Application No. 10/721,694 Reply to Office Action dated April 10, 2006

## Amendments to the Drawings:

## Application No. 10/721,694 Reply to Office Action dated 04/10/06 Annotated Sheet Showing Changes

Fig. 1A

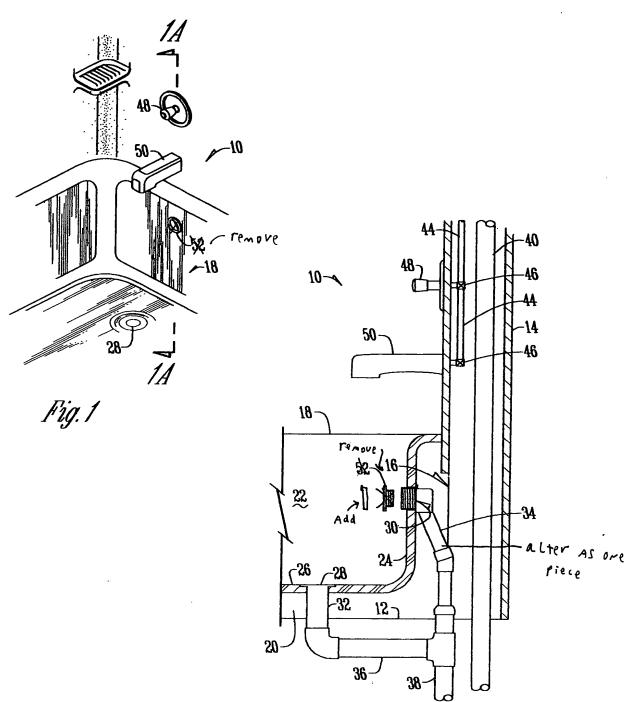
The attached sheet of drawings includes changes to Figs. 1 and 1A. This sheet, which includes Figs. 1 and 1A, replaces the original sheet including Figs. 1 and 1A. In Figure 1, we are replacing cap 52. In Fig. 1A we are replacing cap 52 and changing pipe 34 to one piece construction.
